**SAAB****SERVICE INFORMATION**SI No. **410-1976**Date **June 1998****900**PI No. **4/98 Grupp 4 D 3.0**Distr. **all****Clutch operation complaints**

**Cars affected**

LHD cars with manual gearbox M94-97

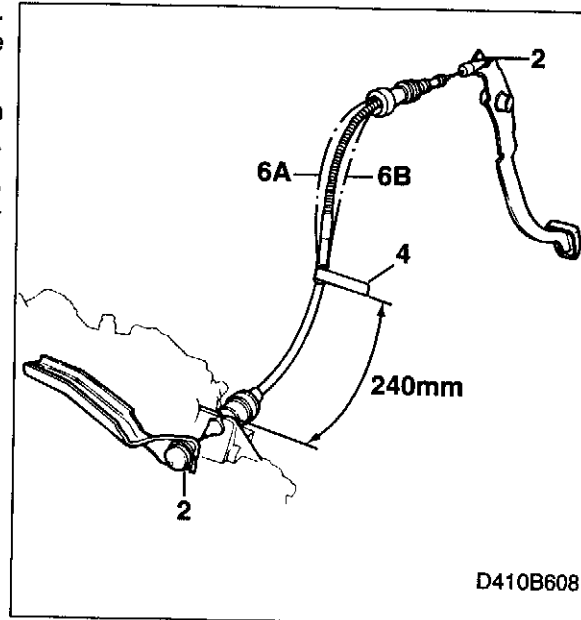
The adjusting mechanism must be completely pressed in towards the firewall for the adjustment to function. Also note that the locating bracket (figure 4) is critical to the correct adjustment and operation of the clutch and cable.

- 4 Inspect and replace bracket, P/N 44 90 249 and screw, P/N 79 72 805, if damaged. Check that the bracket is centered on the sleeve and that the sleeve is fitted according to the measurement in the illustration. Tighten the bracket to the body.
- 5 Check that there is free play in the clutch pedal.
- 6 Check that the clutch cable follows the upper curve (6A) if the clutch is new. There is a need for some excess, since the cable casing is stretched when the clutch is worn and the adjusting mechanism will compensate for this. When the clutch is worn, the cable will follow the lower curve (6B).
- 7 Make sure that the clutch cable has a smooth routing without any kinks or sharp bends.
